# SAN FRANCISCO PLANNING DEPARTMENT

## Discretionary Review Full Analysis

*Date:* June 9, 2016  
*Case No.:* 2015-003610DRP  
*Project Address:* 2181 9<sup>th</sup> Avenue  
*Permit Application:* 2015.03.19.1328  
*Zoning:* RH-1(D) (Residential House, One-Family-Detached)  
40-X Height and Bulk District  
*Block/Lot:* 2860/004  
*Project Sponsor:* Alexander Lirisman  
Forum Design  
1014 Howard Street  
San Francisco, CA 94103  
*Staff Contact:* Nancy Tran – (415) 575-9174  
[nancy.h.tran@sfgov.org](mailto:nancy.h.tran@sfgov.org)  
*Recommendation:* **Do not take DR and approve the project as proposed**

2181 Ninth Avenue  
**Alternate Concepts**

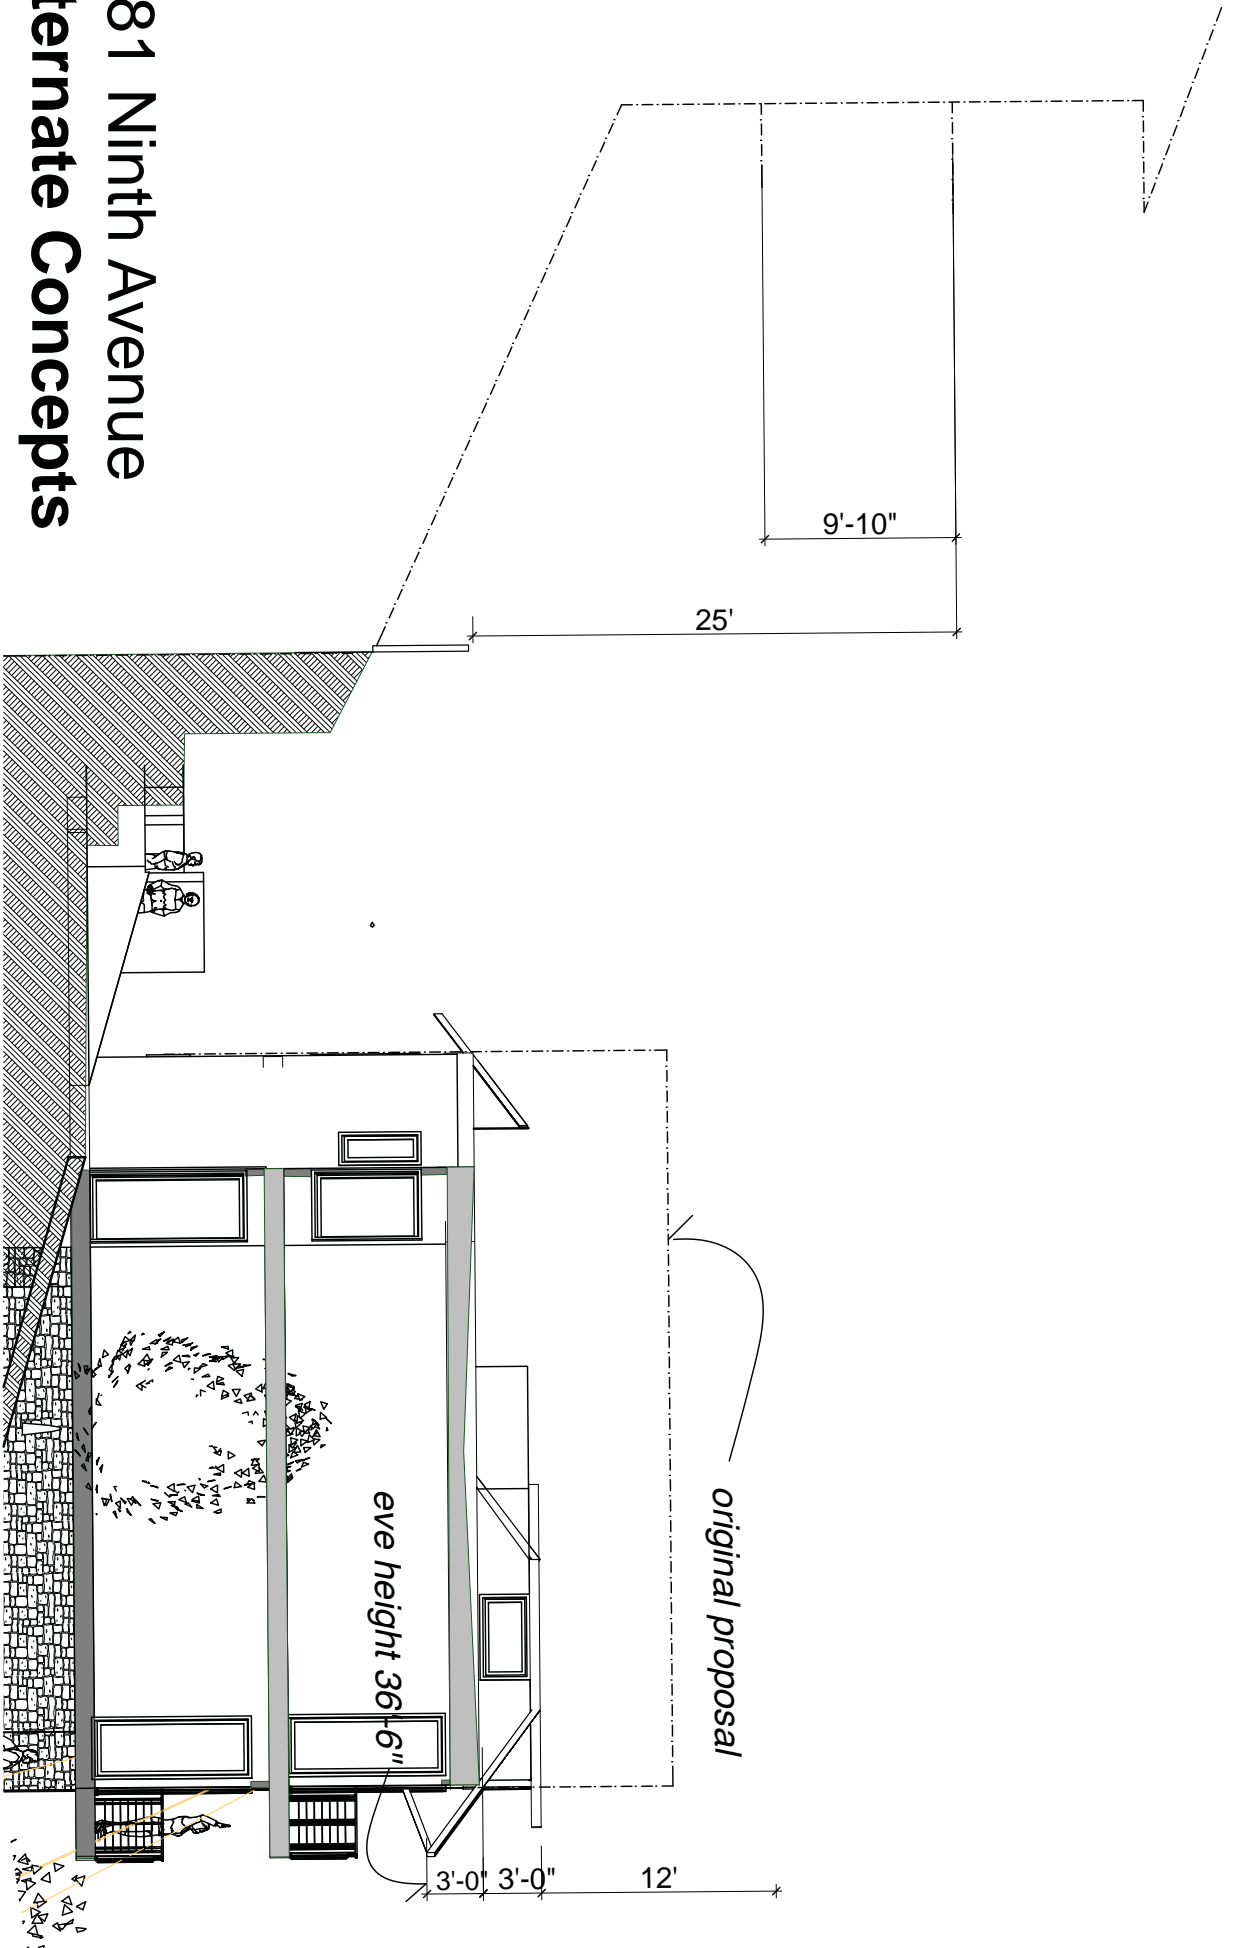
- Reduce the front setback to align the main front facade with neighboring houses, and move the rear facade of the house toward the street. This can be accomplished by moving floors 3 & 4 forward some 4'. see *alt. concept plans*

- Revise front facade to give it a less jarring contrast to the rest of the neighborhood. This includes eliminating the massive front bay that encloses the stairs and the similarly massive architraves around the garage door and front entry. This can be accomplished by (1) turning the stairs so they can be enclosed behind the front wall, (2) changing the material of the recessed second basement wall to accentuate this floor's setback, and (3) reducing the size and number of the front decks, and possibly adding some sloping roofs. Each of these can aid in lowering the visual height of the structure.
